The following is an ECO for the T100S power supply for better reliability. T100S Power Supply Mod
Parts kits are available from ADA.

T100S POWER SUPPLY MODIFICATION

ENGINEERING CHANGE REQUEST ECD # 8808
TITLE T100s negative regulator fix

ENGINEERING CHANGE REQUEST ECO # 8798 A
TITLE T1003 BIG FIX

FIGURE 3

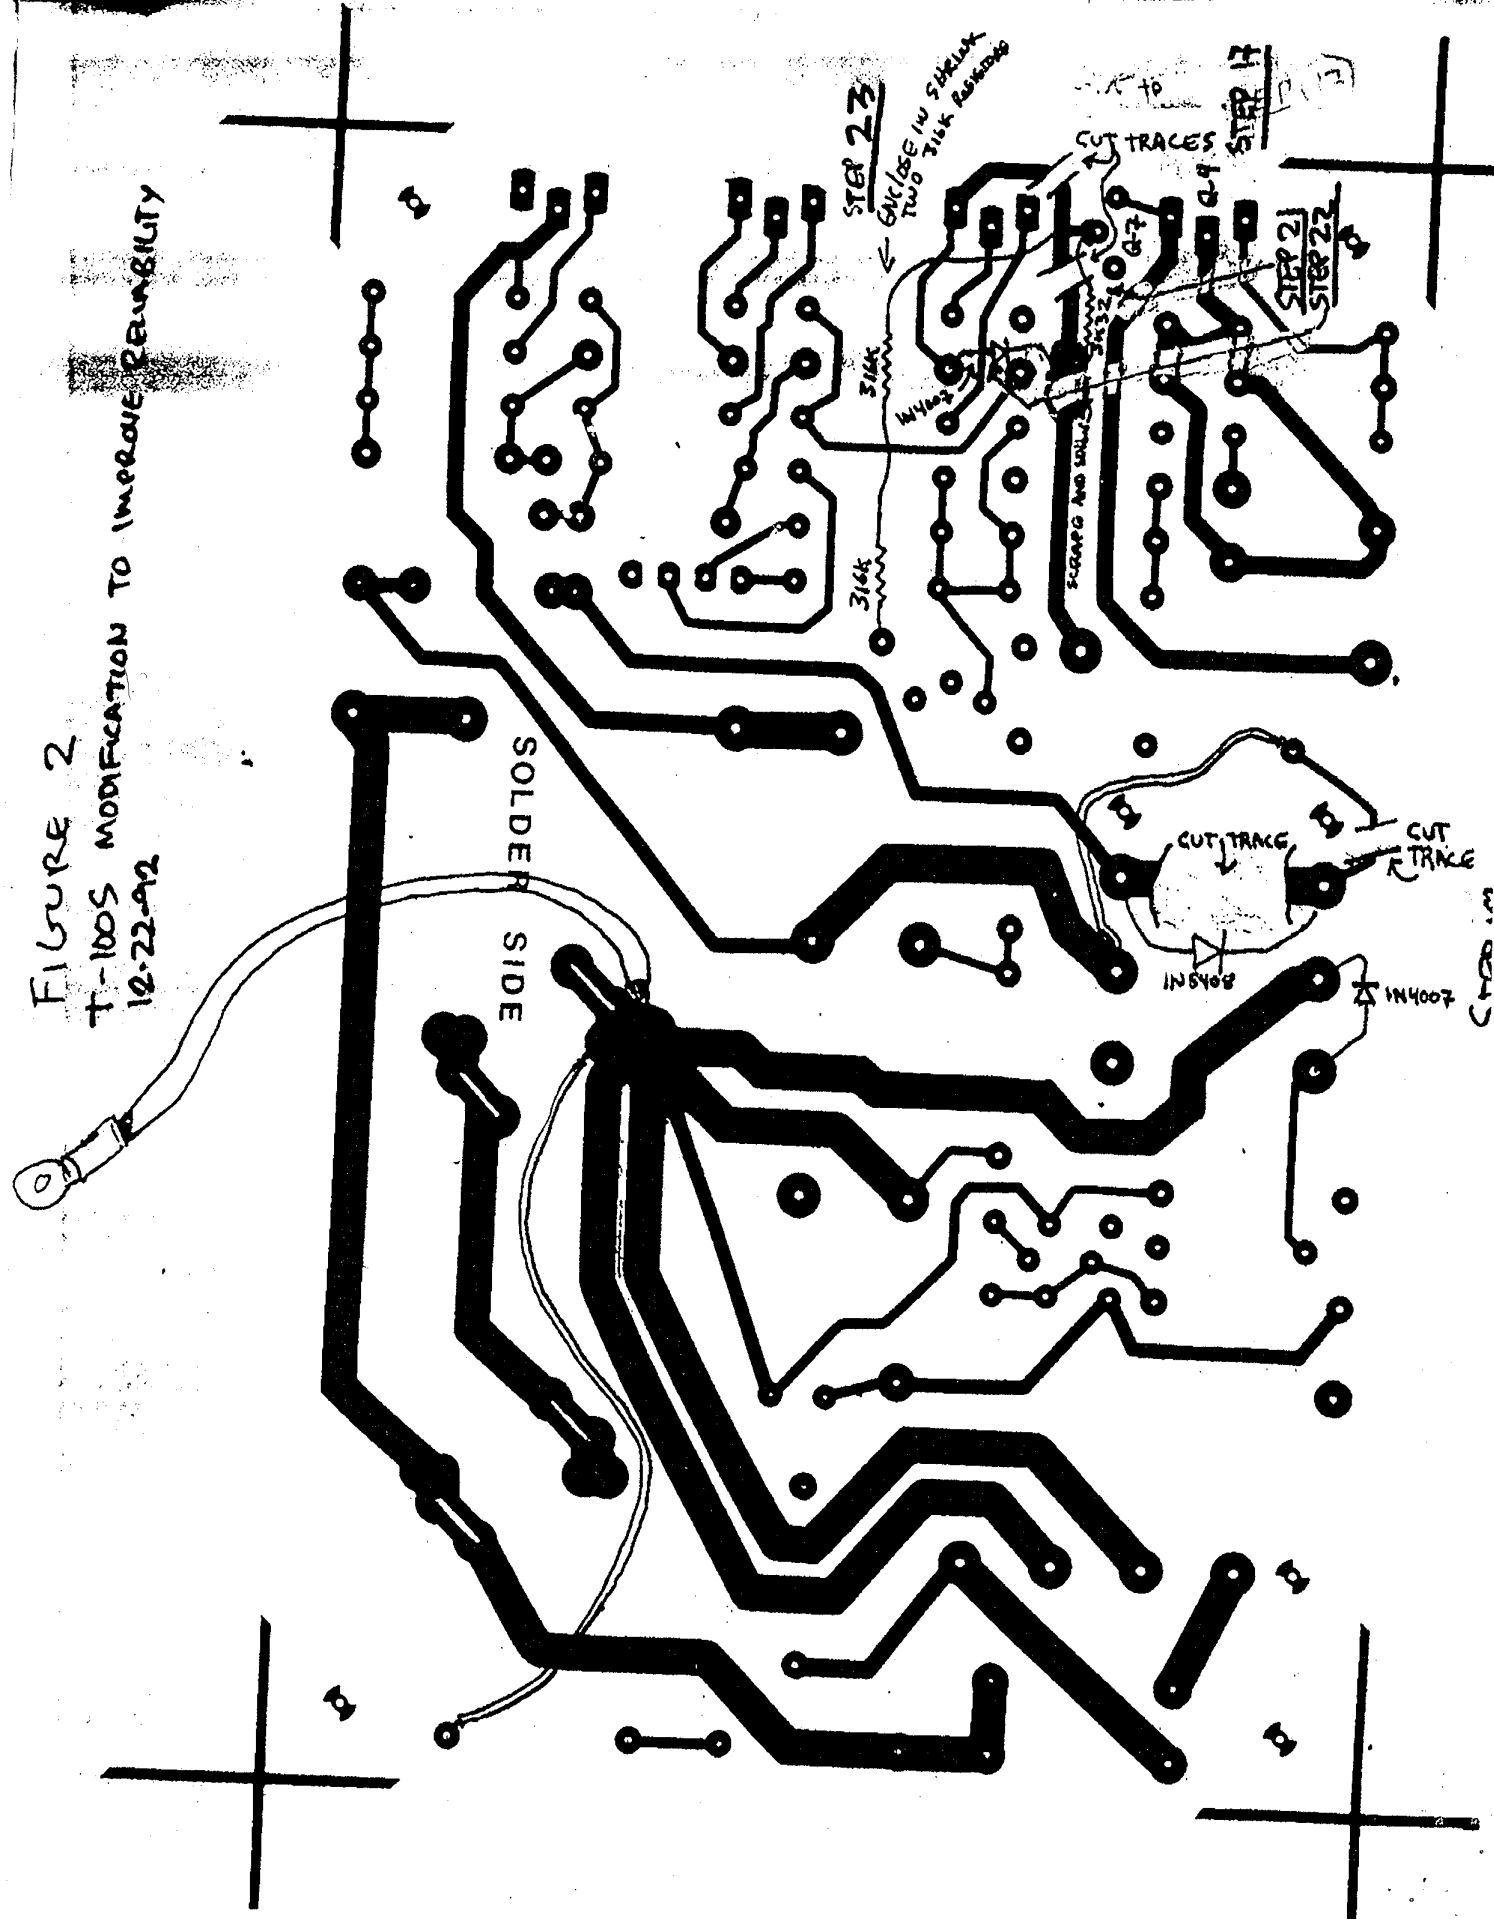
024 REFER AGAIN TO FIGURE 3

024 REPLACE C-4, C-5 WITH 10 μ F/350V OR 10 μ F/450V

025 R-10 BECOMES 4.7 Ω 2W

026 INSTALL TWO JUMPERS AS SHOWN IN FIG 3

027 INSTALL THREE 1N4148 DIODES BETWEEN GATE SOURCE OF Q-4, Q-5, Q-6 AT LOCATIONS INDICATED IN FIG 3

028 INSTALL 1M Ω $\frac{1}{2}W$ FROM D-8 CATHODE TO HOLE INDICATED IN FIG 3

029 INSTALL (3) .0047 μ F/1KV AND (3) 220K $\frac{1}{4}W$ IN LOCATIONS INDICATED IN FIG 3

030 INSTALL IRF 731 MOSFETS AT Q-4, Q-5, Q-6 AND MOUNT TO HEATSINK WITH NEW HARDWARE.

NEW PARTS AND JUMPERS
LOCATIONS FOR MODIFICATION
12-22-92 (IMPROVES RELIABILITY)

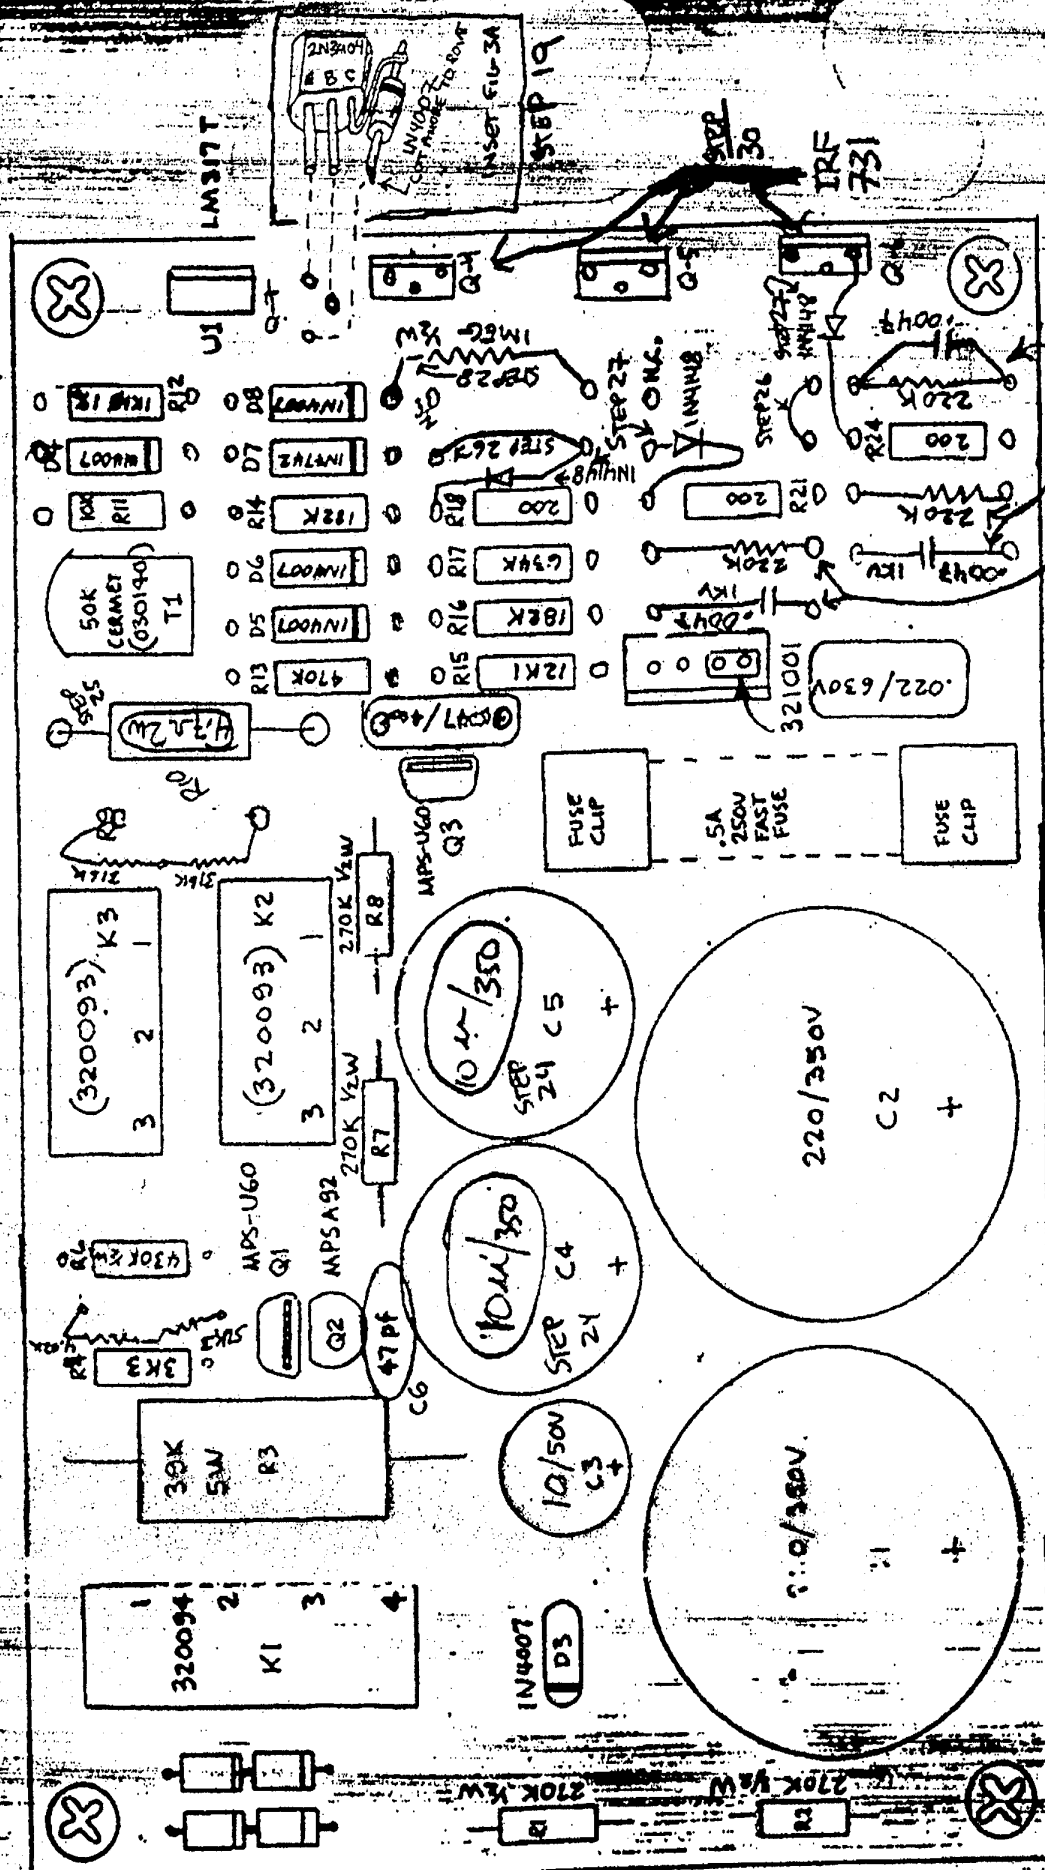
STEP 29

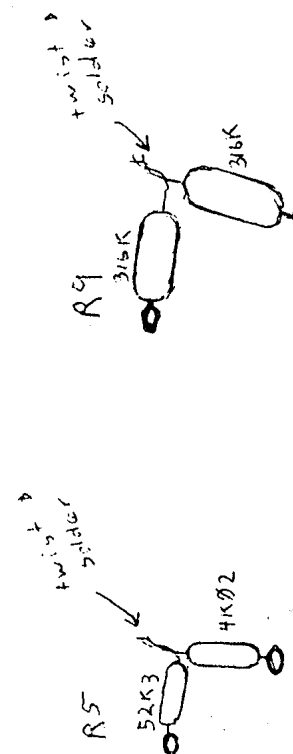
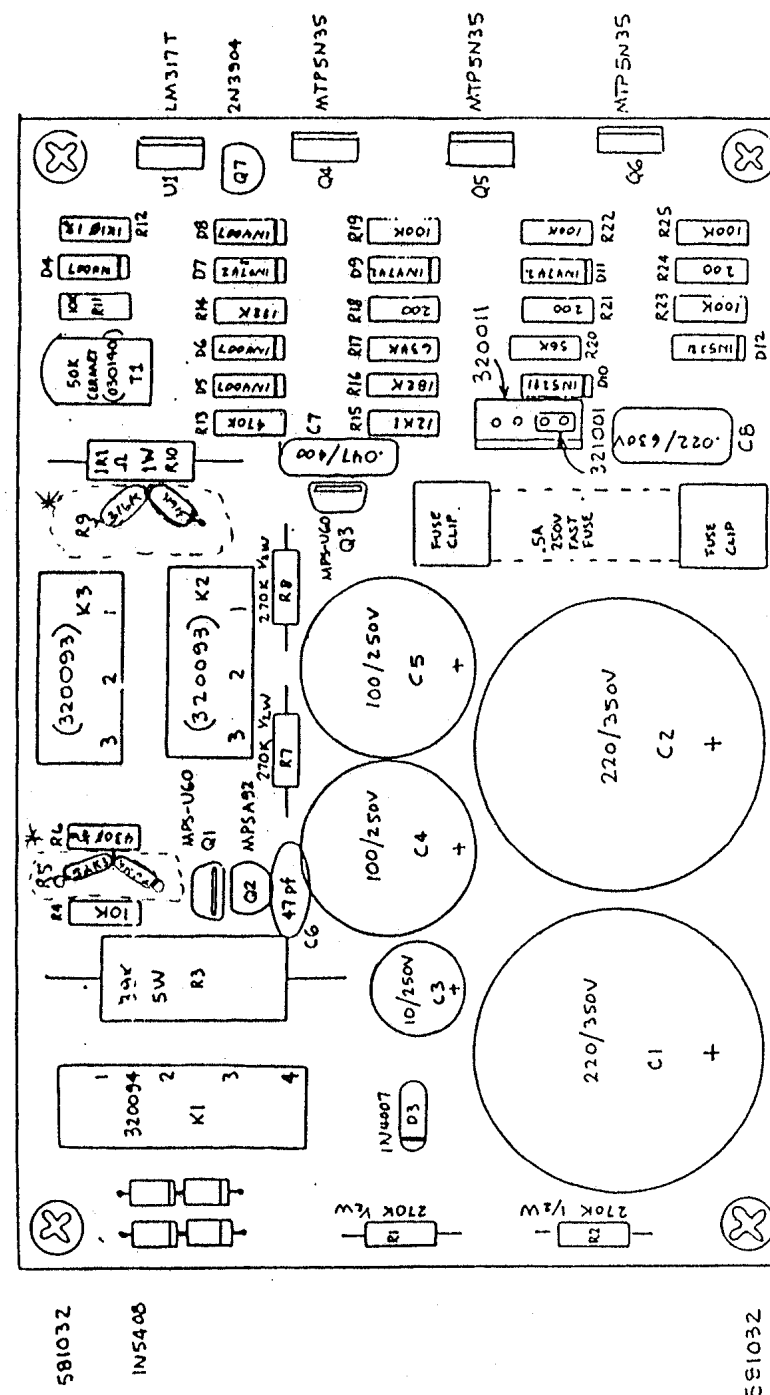
R9 (316K 1/2W resistor) is not power rated properly.

add (1) 316K 1/2W in series with R9

change R5 from 28K7 to a 52K3 1% in series
with a 4K02 1%

ECO# 8798 A TITLE T1003 BIG FIX

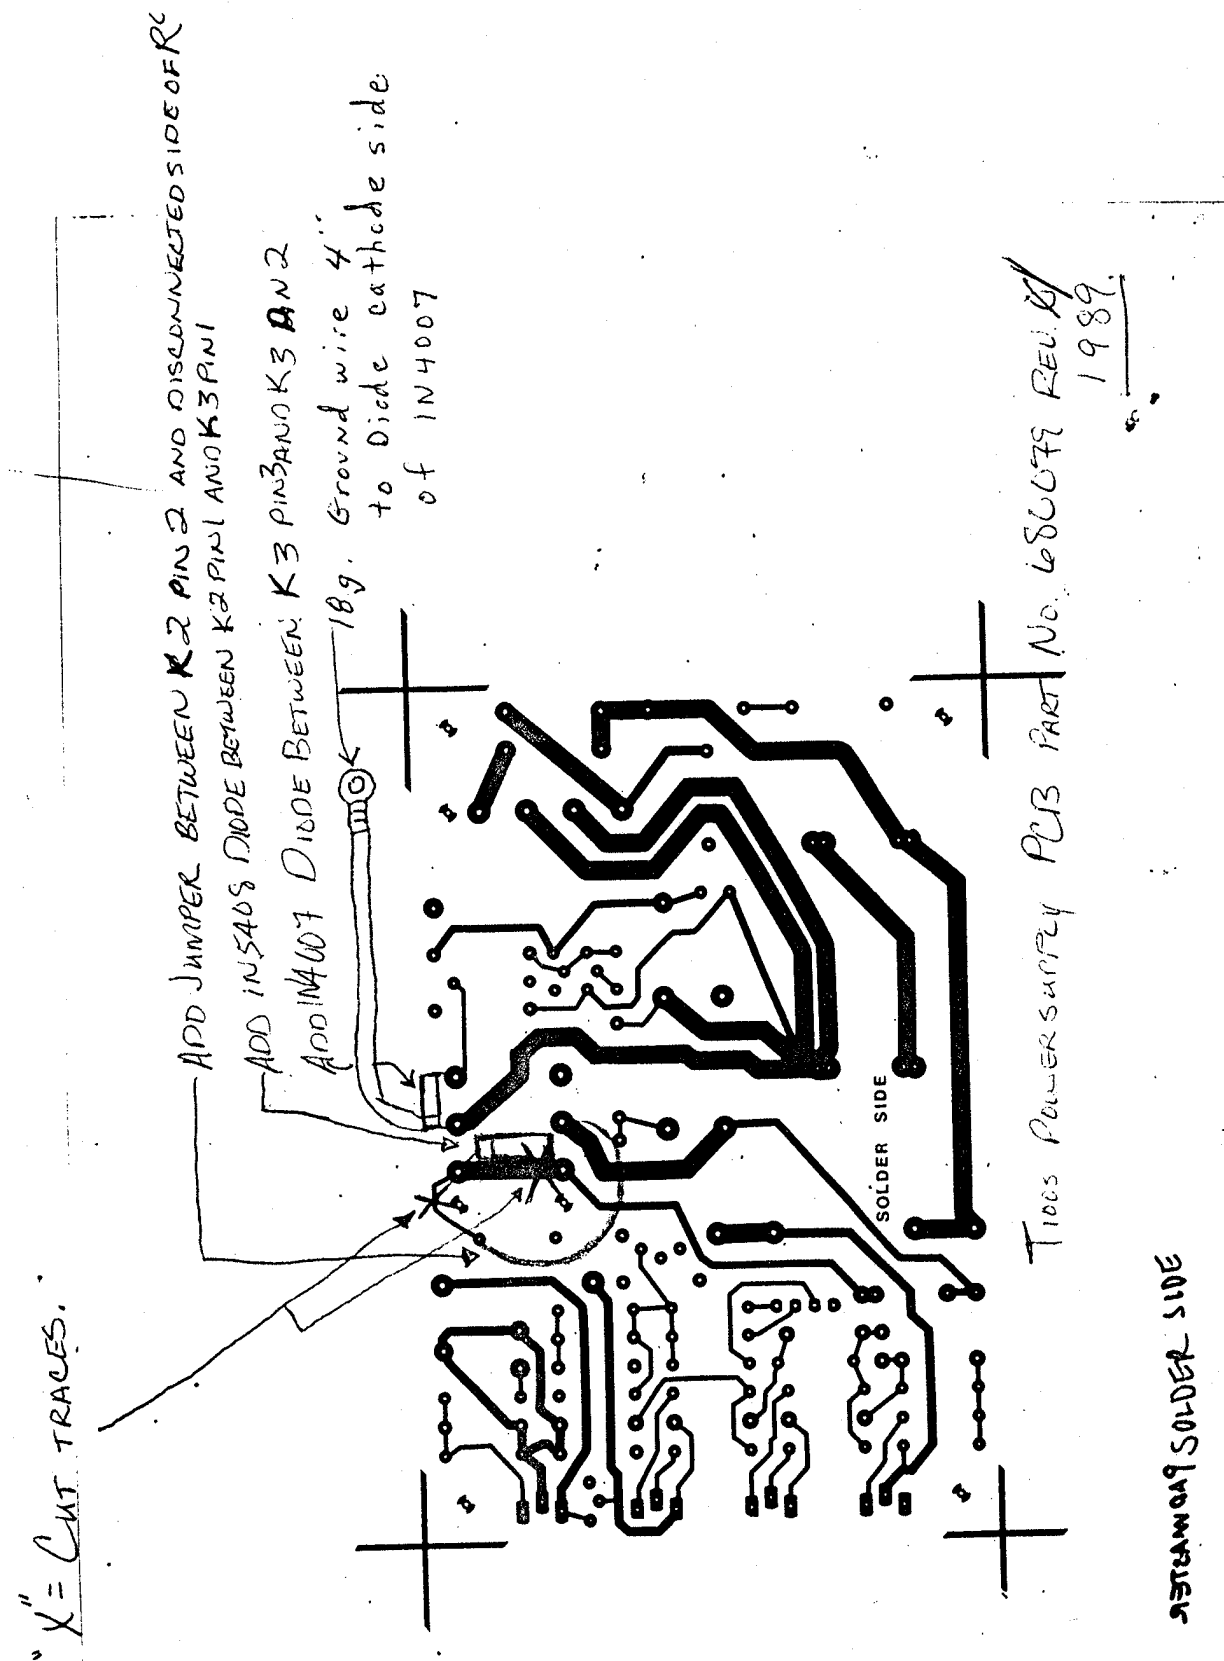
Power supply unprotected from fly back effect
of output Xfmr.

- CH' GE(S):
- 1) CUT TRACES: K2 PIN 1 AND K3 PIN 1, K3 PIN 1 AND R9.
 - 2) ADD IN5408 DIODE BETWEEN K2 PIN 1 (ANODE), AND K3 PIN 1 (CATHODE).
 - 3) ADD IN4007 DIODE BETWEEN K3 PIN 3 (ANODE), AND K3 PIN 2 (CATHODE).
 - 4) ADD JUMPER WIRE BETWEEN K2 PIN 2 AND DISCONNECTED SIDE OF R9.
 - 5) CHANGE C3 TO 10uF/100V.
 - 6) CHANGE NO. 6 SCREWS, FOR TRANSISTOR MOUNTING, TO NYLON SCREWS.
 - 7) CHANGE R9 TO 316K Ω 1/2 WATT R.
 - 8) ADD 4" AWG 18 WIRE. CONNECT RING TONGUE CONNECTER NO. 6 TO ONE END. OTHER END TO K3 PIN 2. AFTER POWER SUPPLY IS INSTALLED, CONNECT NO. 6 LUG TO AC. THIRD PRONG (CHASSIS BOLT).

T1005 PWR SUPPLY PCB
8-24-89 / 10-17-89
SUBASSEM 780008 REV B
PCB 680079 (B552)
REV 11-10-89 DJT
REV 4-11-90 DJT

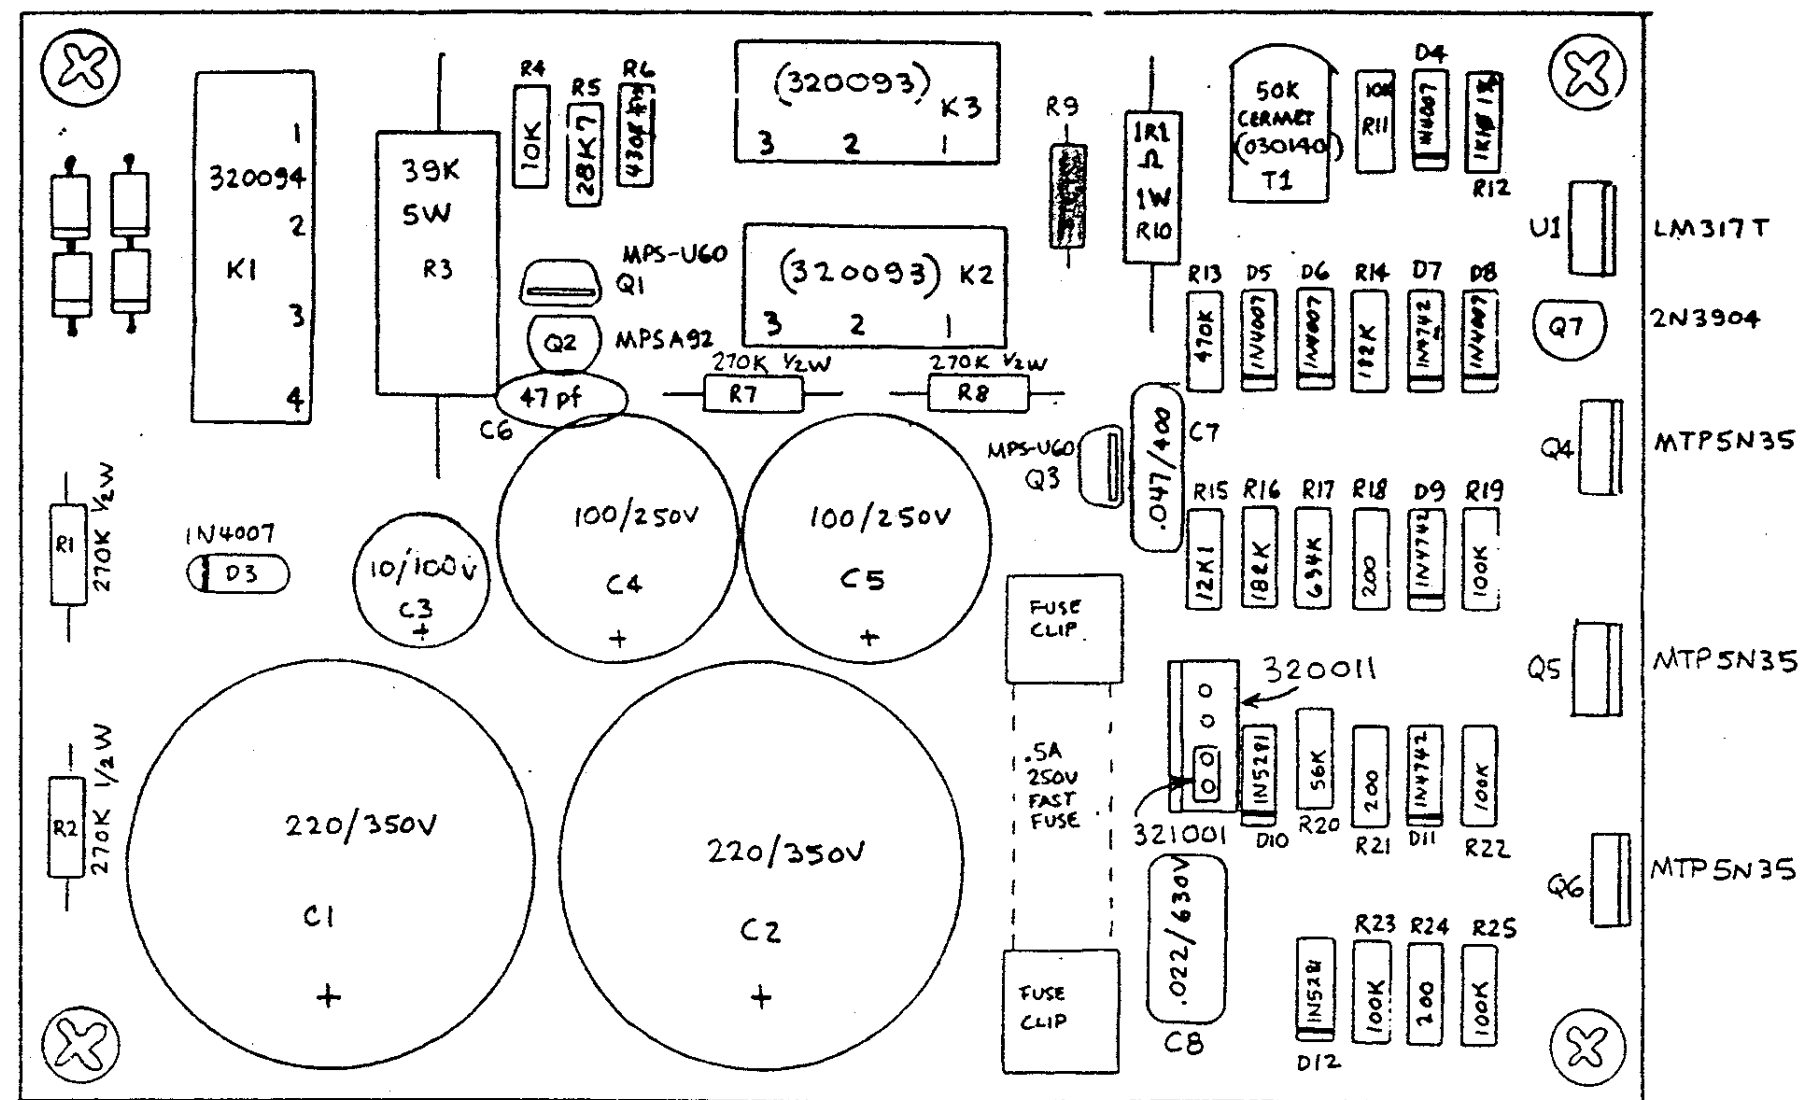
4 ea - IN5408

10 uF/100V CAP. P/N 0820434

316K 1% 1/2 W (014649) 1
